Whittlesea Planning Scheme Amendment C188: Quarry Hills PSP

**AMENDMENT C188 TO THE
WHITTLESEA PLANNING SCHEME**

Quarry Hills PSP

Expert Evidence By: Jonathan Ladson
JCA Land Consultants

Image 2: PSP Plan 1 showing precinct features including colour coded slope analysis.

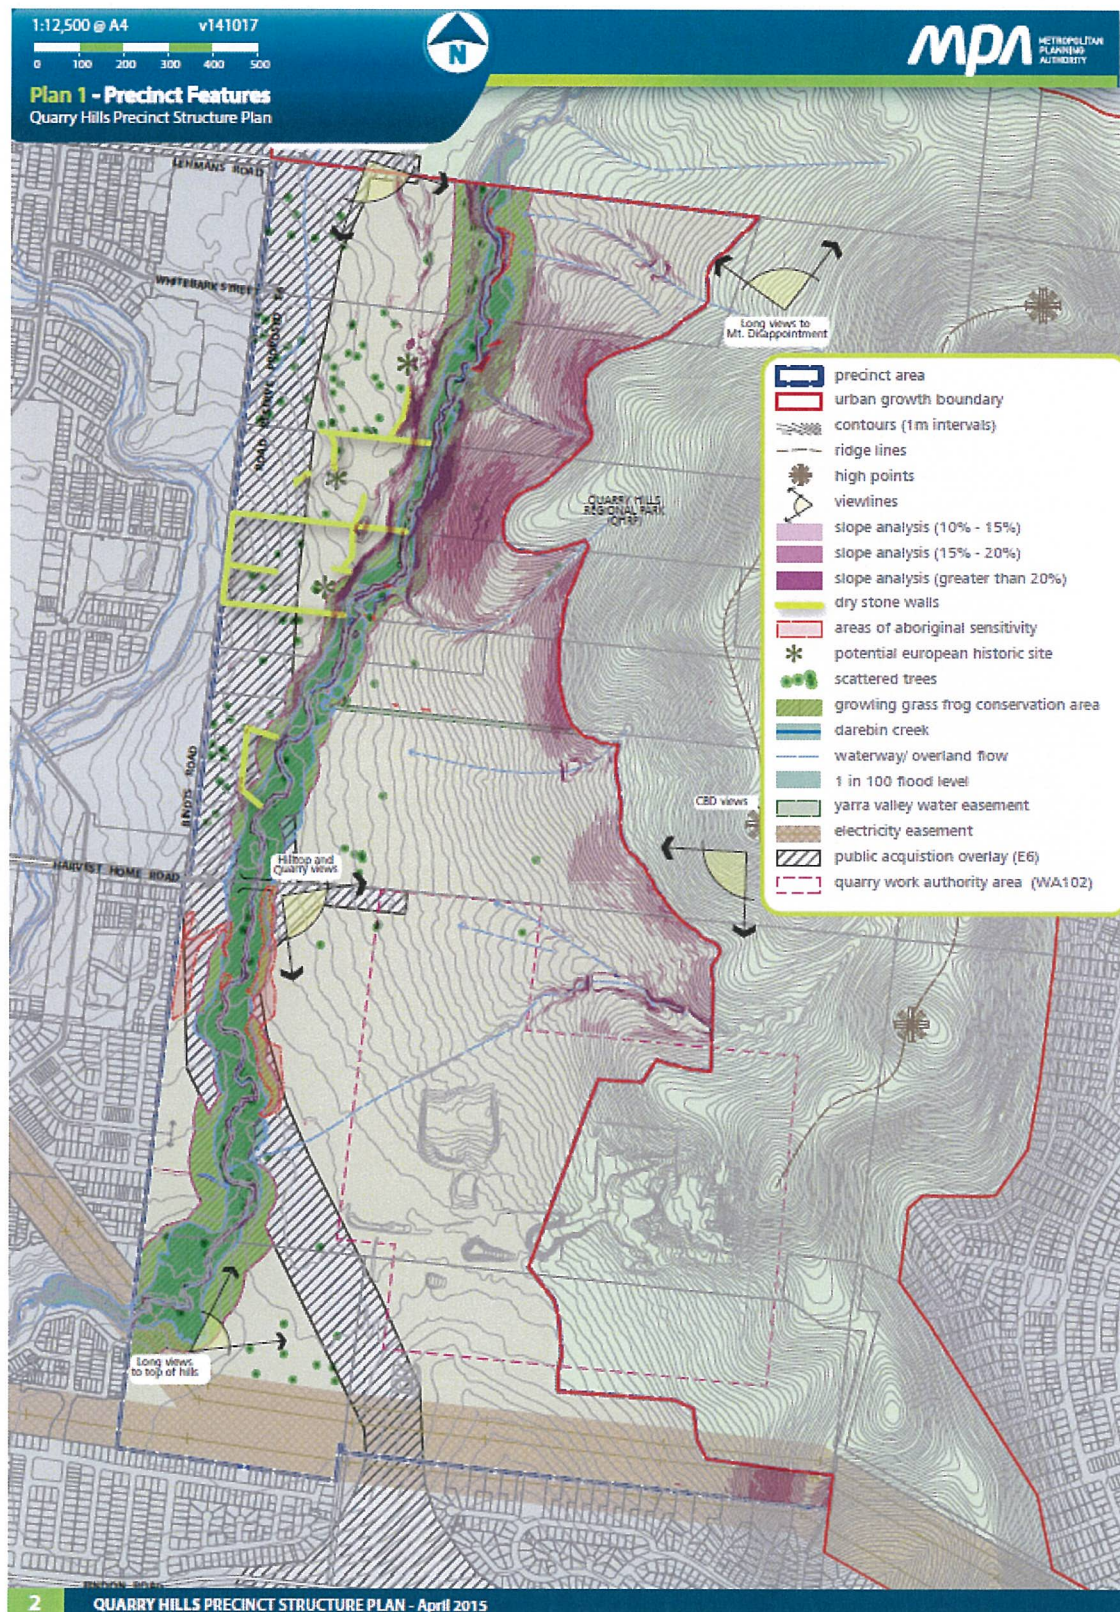
Plan 1 on page 2 of the PSP indicates some of the features of the precinct and in relation to this report indicates areas of percentage slope via colour code. This plan is reproduced for convenience in image 2, below. From a review of this plan, it can be seen that the majority of the site has a slope of less than 10%. This percentage rate of slope, which equates to 1:10 or 5 degrees, is not considered a constraint on development.

Approximately 10% of the site, particularly at the rear of 90, 100 and 130 Bindts Road, has slopes that range from 10% up to 20%. It is these areas that provide a constraint to development and the PSP attempts to address design responses to this slope in later sections.

Image 3: reproduction of Plan 10 showing bushfire prone area on land interfacing the Quarry Hills Regional Park.

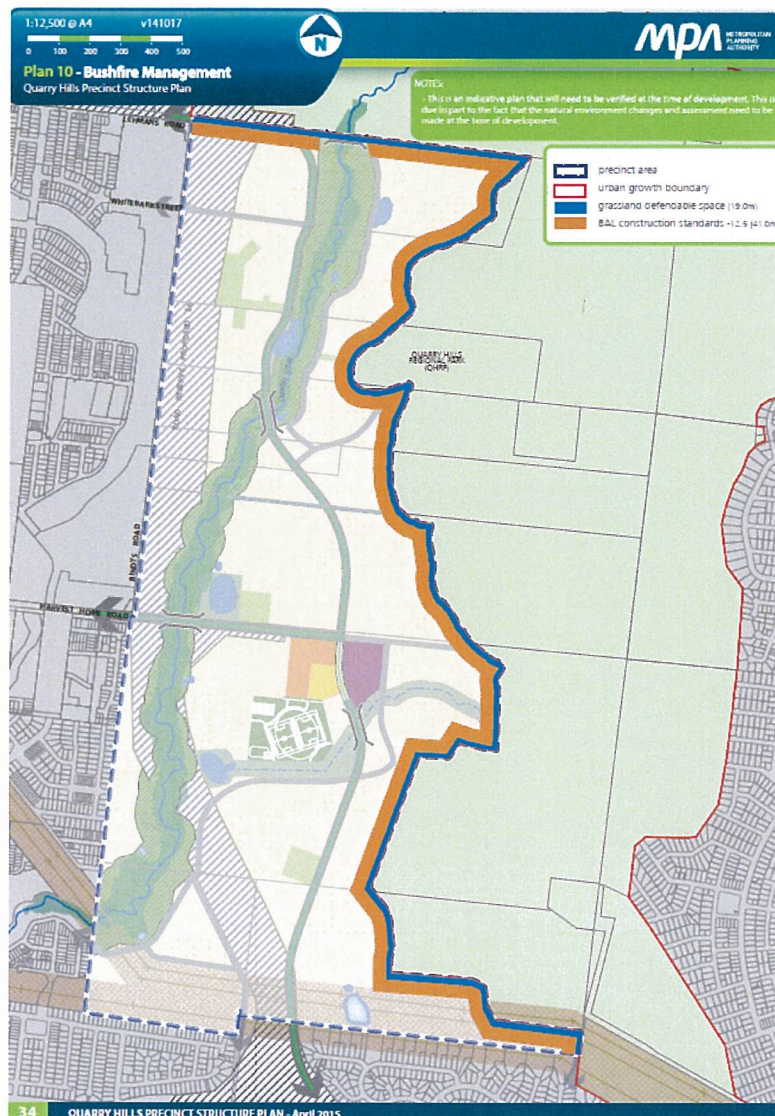
The Diagrams relating to Bushfire Management are shown on plan 34 and 35 of the PSP. The "requirement" R28, refers to lots with an interface with the Quarry Hills Parkland, Darebin Creek or Conservation areas. The Bushfire Management (Plan 10) on page 34 shows lines that indicate grassland defendable space and BAL construction standards, however these lines only refer to the land with an interface with the Quarry Hills Parkland, there is no indication of Bushfire Management requirements on the land with an interface with the Darebin Creek or any other conservation area. See Image 3 below. This is also the case for figure 7 in the PSP, see image 4.

Plan 10 should include clear reference to the fire prone nature of the interface and that future dwellings must be designed to the appropriate BAL rating. R28 could then be reworded as follows:

R28 – Any dwellings within 60 of the Quarry Hills Regional Park, as shown in Plan 10 of this PSP, are considered to be within a fire prone area and must be appropriately sited and constructed to a BAL rating that complies with the relevant CFA and Australian standards for buildings in a fire prone area.

Figure 7: Bushfire Prone Area Interface

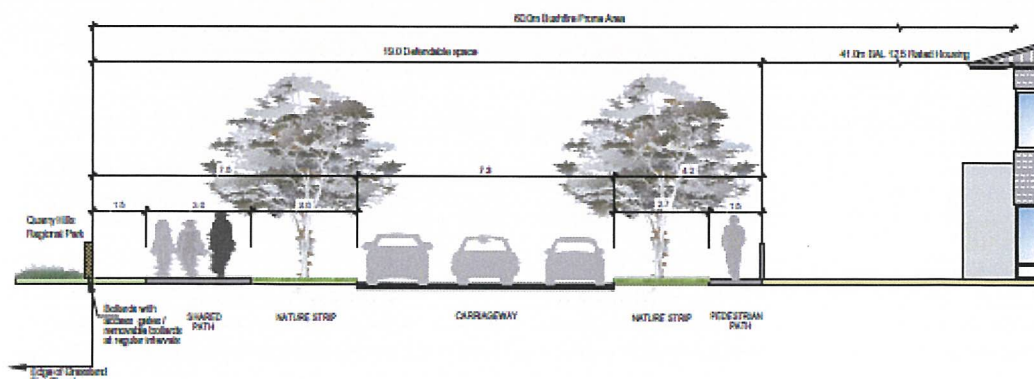
In this perspective the R28 appears to overstate the scope of the bushfire management diagrams and in particular figure 7. Figures 5 and 6 of the PSP appear to contradict the current wording of R28 as no setback requirements to dwellings are shown on these diagrams.

Additionally, Figure 7 shows a 60 metre setback to the Quarry Hills Regional Park for a 12.5 BAL rated dwelling. This is misleading and confusing. Both diagrams are indicating that any land within 60m of the unmanaged grasslands with the Quarry Hills Regional Park is to be considered "Fire Prone". Any construction within the fire prone area must then accord with the CFA requirements for defendable space and the corresponding BAL rating. The setback for any building can then be determined by the BAL rating of the proposed building, and could conceivably be less than 60m. The diagrams within the PSP fail to convey this appropriately and figure 7 should be deleted.

The Road format of Figure 7 could be included in section 4.2 of the PSP without the reference to building setback requirements.

Appendix B: Figure 1, 2, 3 from the PSP

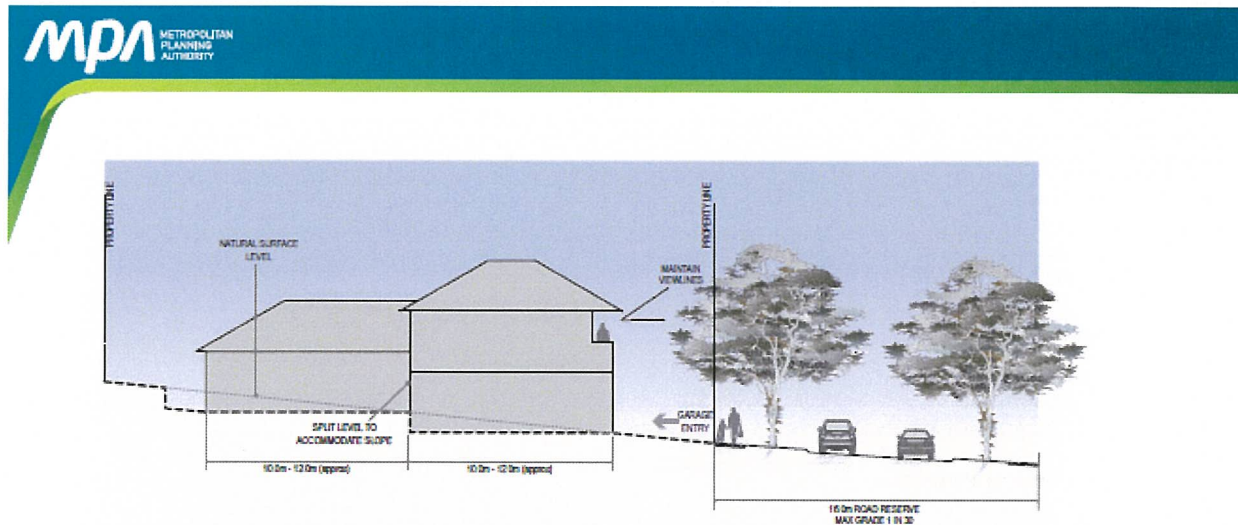
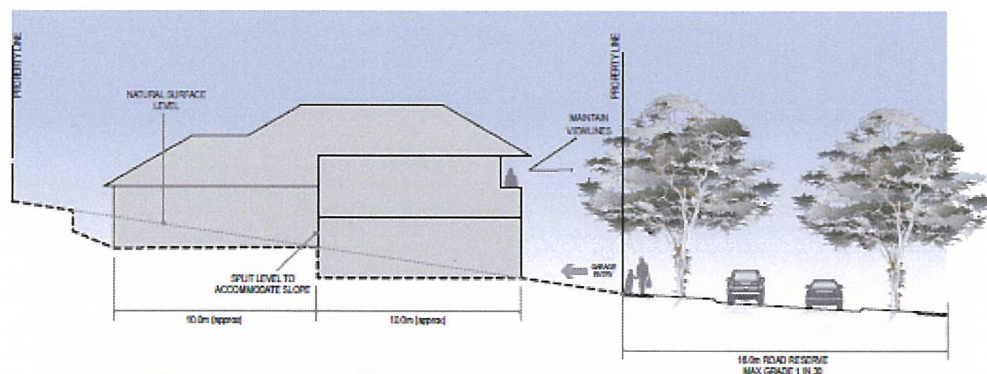
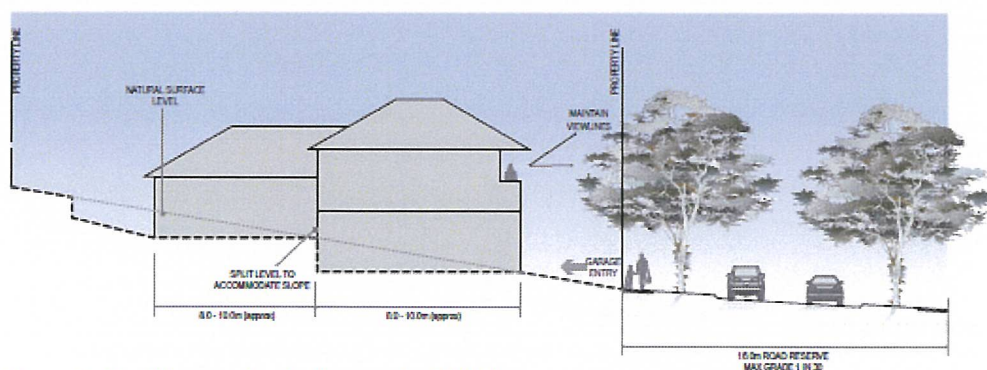
The reference to figures 1, 2 and 3 to provide guidance is somewhat problematic. The emphasis of the guideline is for “subdivision applications” whereas the figures referenced provide little guidance for subdivision design and what can be inferred from the figures is shown incorrectly (or at least inaccurately). These figures are reproduced in Appendix B and more accurate figures are included in Appendix C for comparison purposes.

It is suggested that the figures be deleted as in the current form they are misleading and do not provide adequate guidance for subdivision applications. Adequate guidance could be achieved by inserting the following guidance statements.

The reference to figures 1, 2 and 3 to provide guidance is somewhat problematic. This is listed a "requirement" rather than a "guideline" and yet the figures 1 – 3 are inaccurate and provide non-specific requirements. They are poorly conceived if they are intended to provide the "requirements" for housing or house siting.

It is suggested that the figures be deleted as in the current form they are misleading and do not provide adequate guidance for house siting. Adequate guidance could be achieved by relying on R23.

- *Subdivision applications which include land identified as being in excess of 10% slope should consider street levels and orientations during the design phase to reduce the magnitude of earthworks.*

- *Subdivision applications which include land identified as being in excess of 10% slope should consider lot orientations with respect to slope during the design phase to consider the likely built form of future dwellings.*
- *Subdivision applications which include land identified as being in excess of 10% slope should include building design guidelines to guide and assist the design of buildings in a manner that reduces the magnitude of earthworks.*
- *R22 In areas which contain slope in excess of 10% as identified on plan 1, (of the PSP) development must minimize landscape scaring and large amounts of cut and fill. Specific guidance relating to this can be found at figure 1-3 (of the PSP).*
